Well Name: WARREN UNIT	Well Location: T20S / R38E / SEC 27 / NESE /	County or Parish/State: LEA / NM
Well Number: 344	Type of Well: OIL WELL	Allottee or Tribe Name:
Lease Number: NMLC031695B	Unit or CA Name: BLINEBRY-TUBB-DRINKARD WATERFL	Unit or CA Number: NMNM71052H
US Well Number: 300254028200S1	Well Status: Producing Oil Well	Operator: APACHE CORPORATION

Notice of Intent

Type of Action: Plug and Abandonment

BLM: Updates to procedure noted on procedure with proposed WBD

PROPOSED PROCEDURE

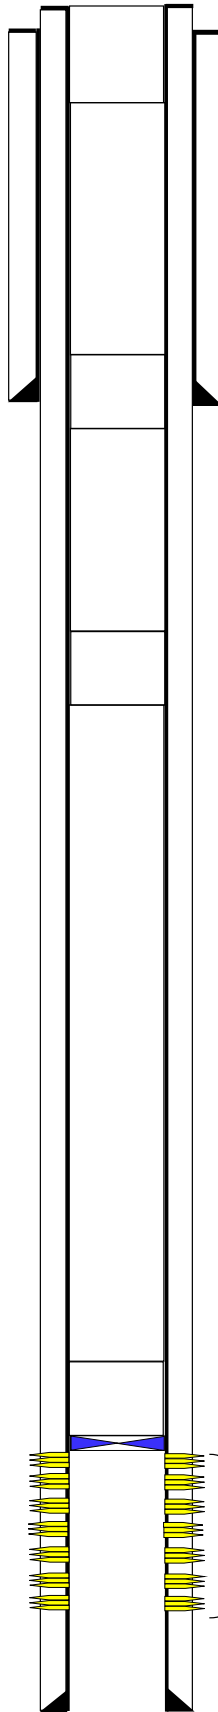
Leak test first barrier: 500psi, 30mins. Including Glorietta

Plug Type	Top	Bottom	Length	Tag	Sacks	Notes
Surface Plug	0.00	300.00	300.00	Verify circulated to surface	30.00	
Top of Salt @ 1529	1463.71	1579.00	115.29	WOC and Tag	25.00	Same as below plug
Fresh Water @ 1529	1463.71	1579.00	115.29	WOC and Tag	25.00	Same as below plug
Shoe Plug	1514.20	1630.00	115.80	WOC and Tag	25.00	
Yates @ 2780	2702.20	2830.00	127.80		25.00	
Glorieta @ 5500	5395.00	5550.00	155.00	WOC and Tag	60.00	Same as below plug
CIBP Plug	5965.00	6000.00	35.00	Verify CIBP depth	60.00	Leak test 500psi, 30mins

No more than 2000' is to be allowed between plugs in open hole, and no more than 3000' between plugs in cased hole.

R111P: Solid plug in all annuli - 50' from bottom of salt to surface.
